Addendum: **1**

Date: **03/14/2025**

Project: **SACS 2025 Chiller Replacements**

AB-M201

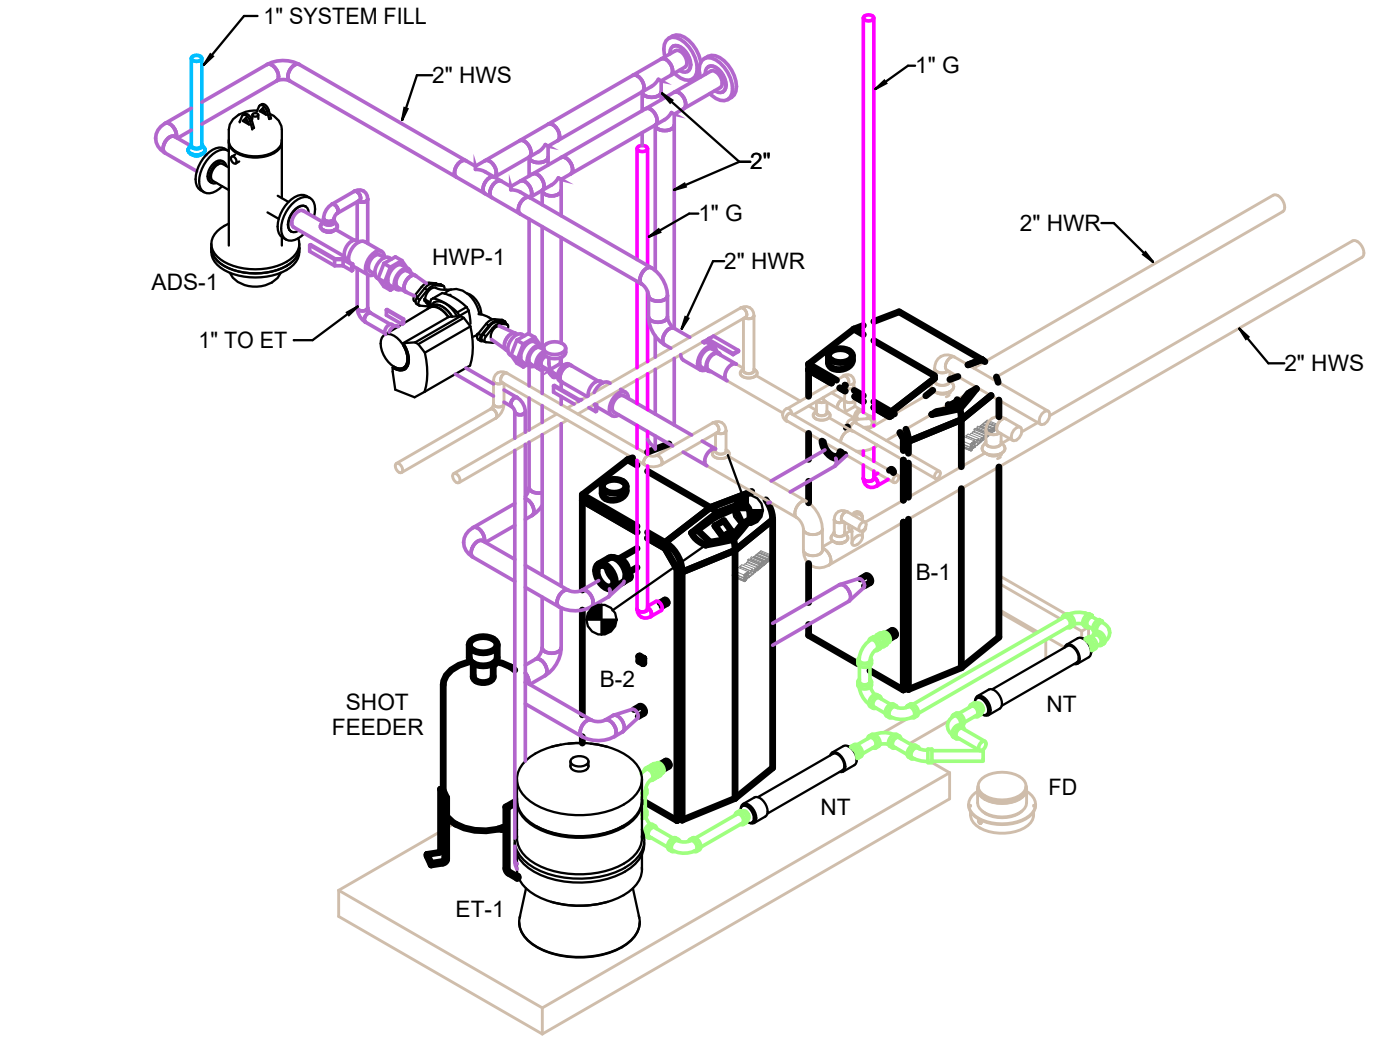
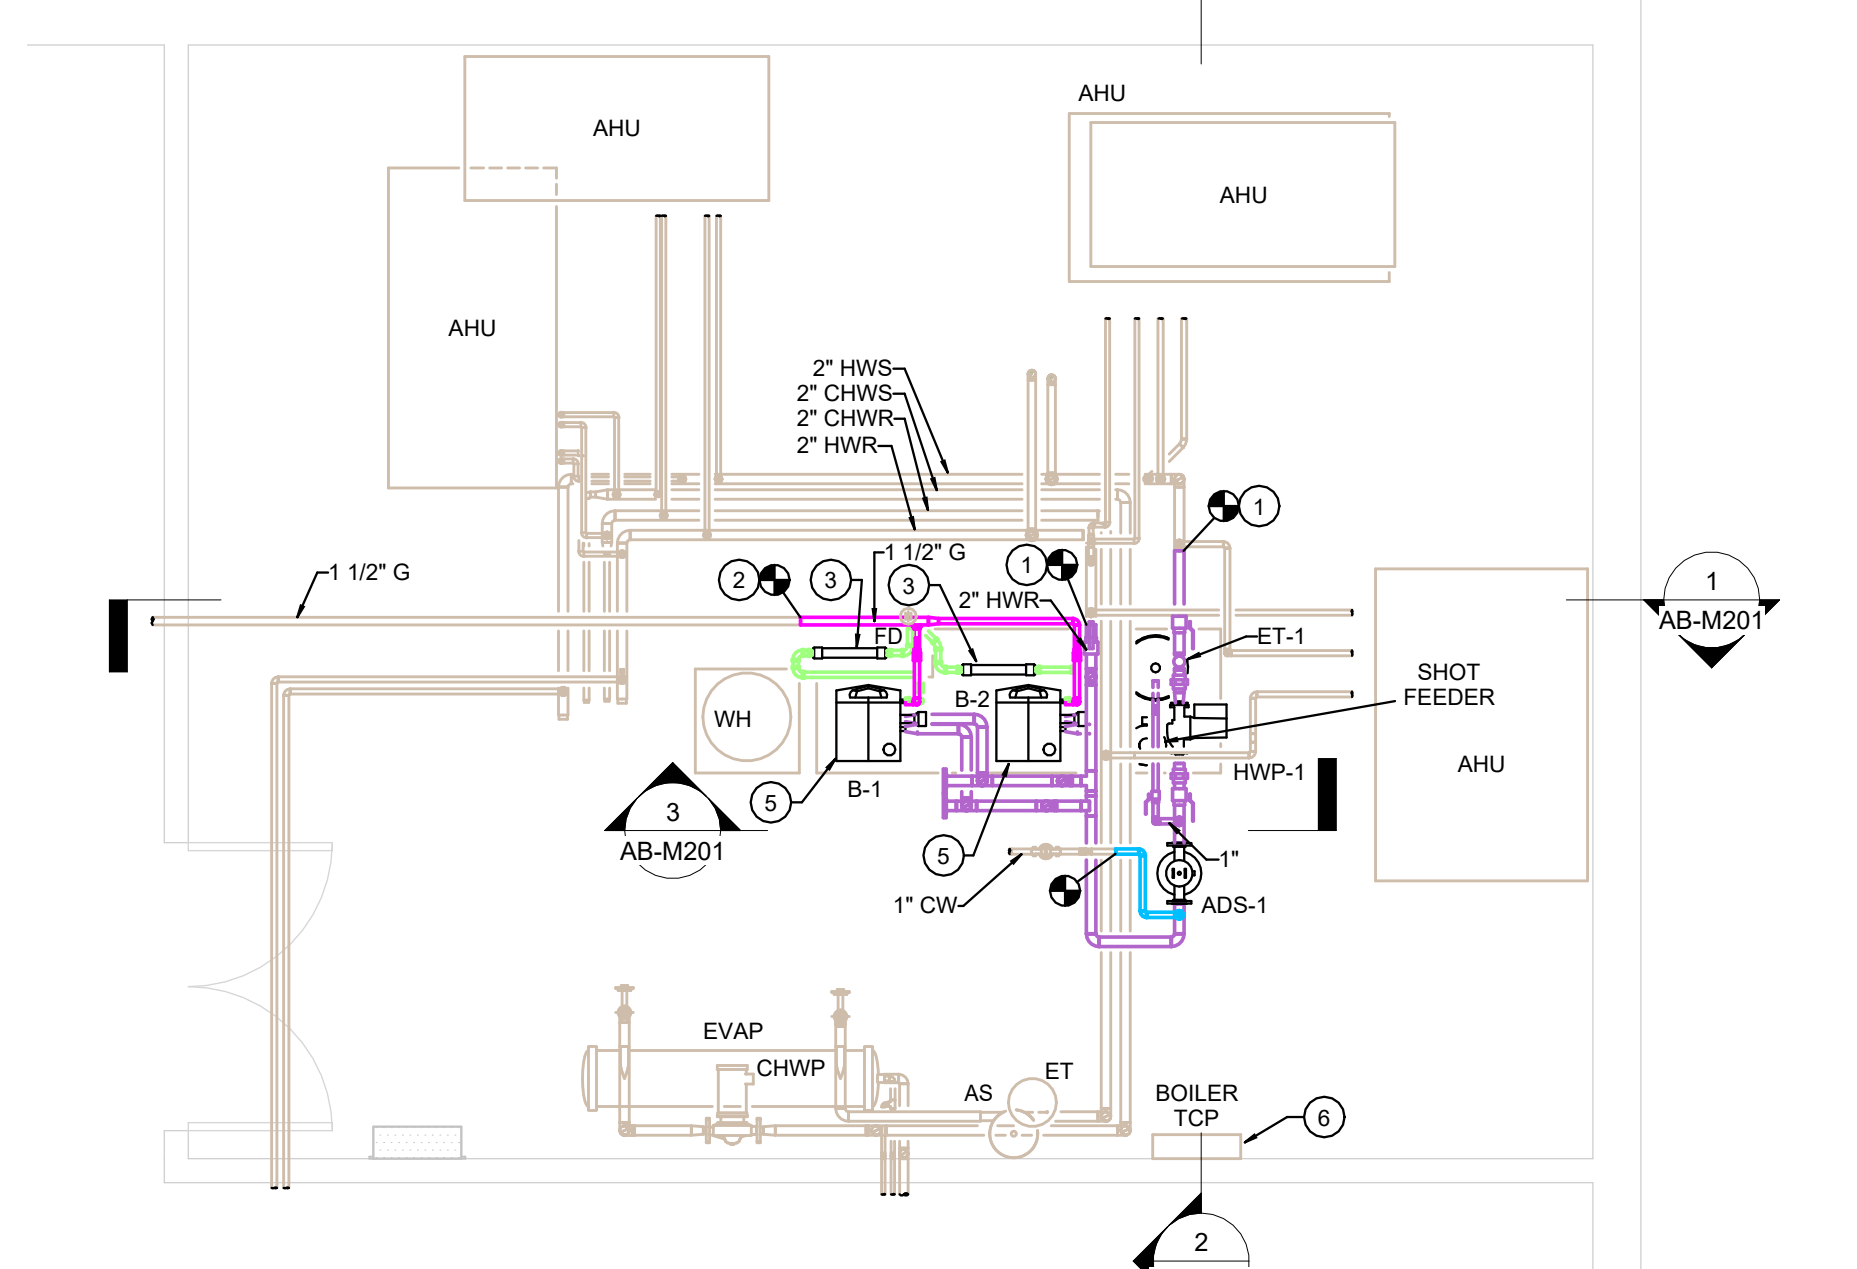
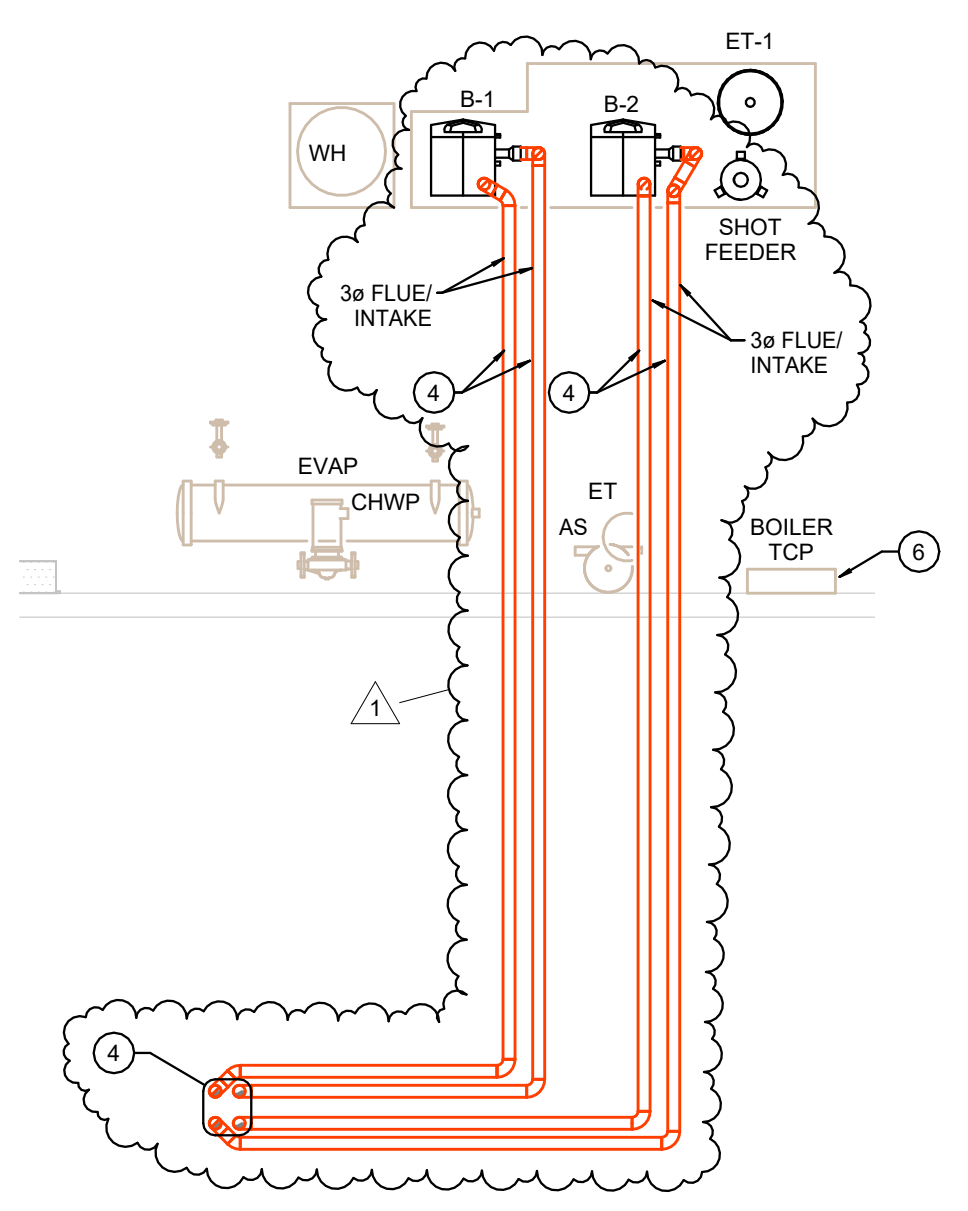
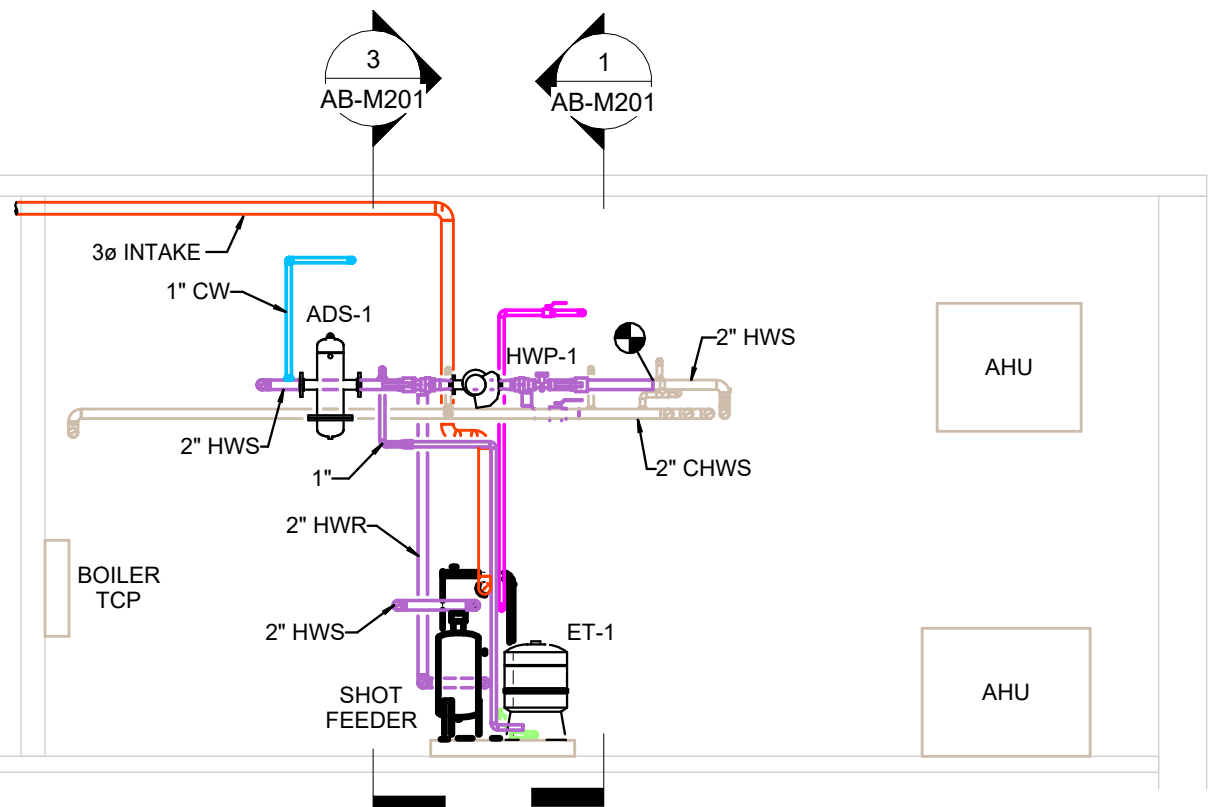
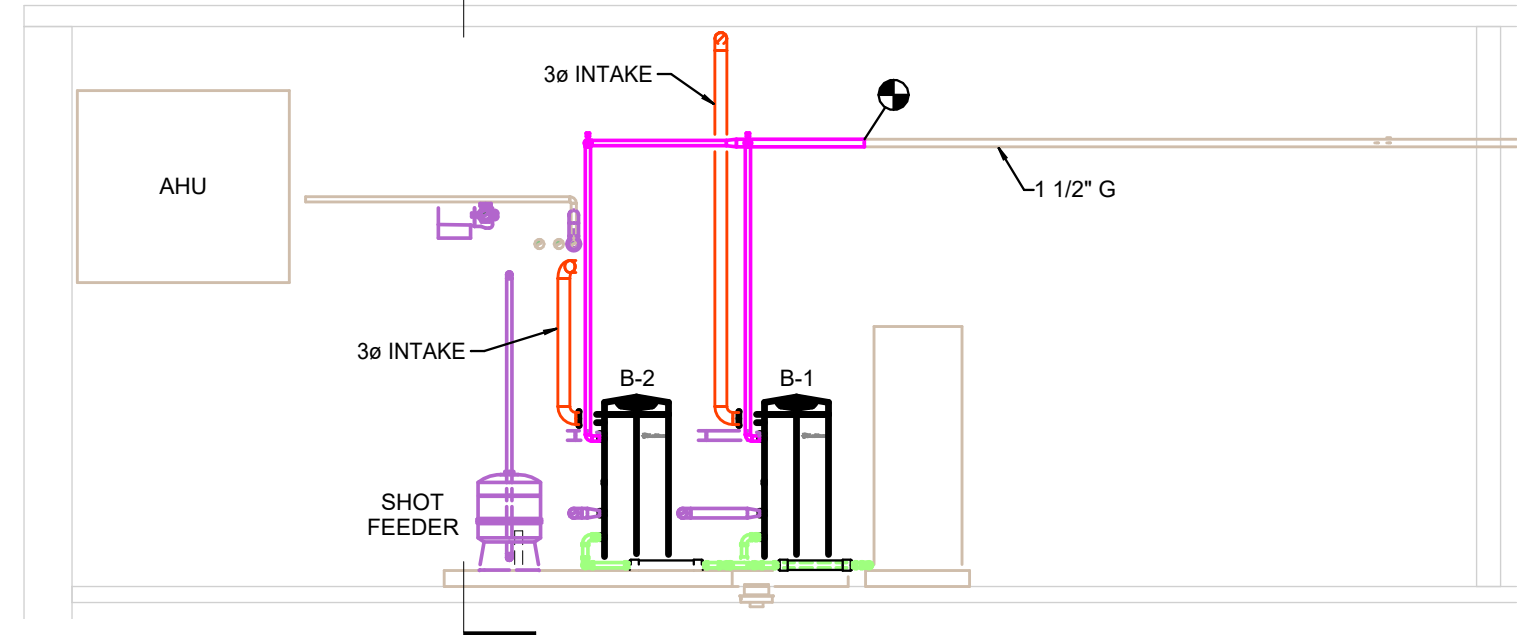
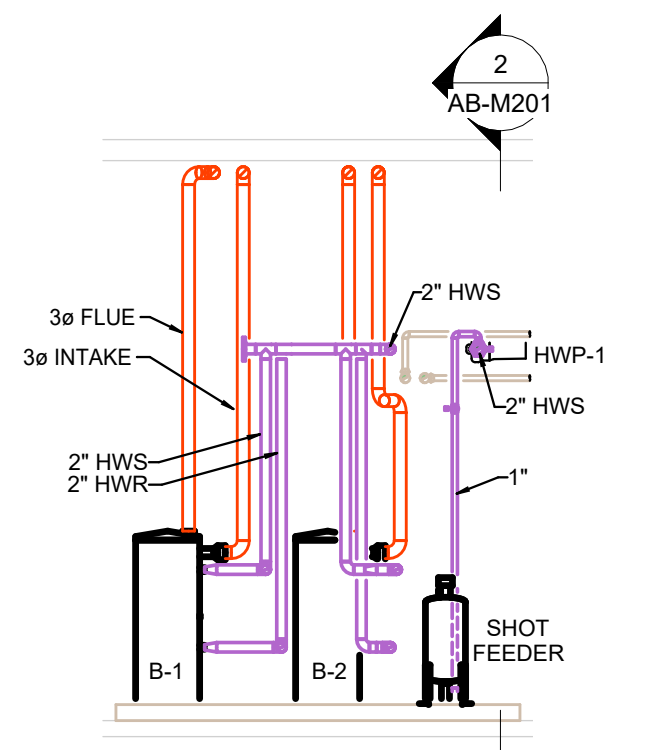
- F. Question: *“Please confirm the Administration Building Flue length is okay.”*
Response: See revised routing on sheet M201 below.
- G. Question: *“What is the system volume of chilled water plants?”*

- A. Revised boiler flue/intake to eliminate elbows. Approximate equivalent length of pipe is 97'. Refer to supplemental drawing sheet AB-M201, labeled addendum #1.
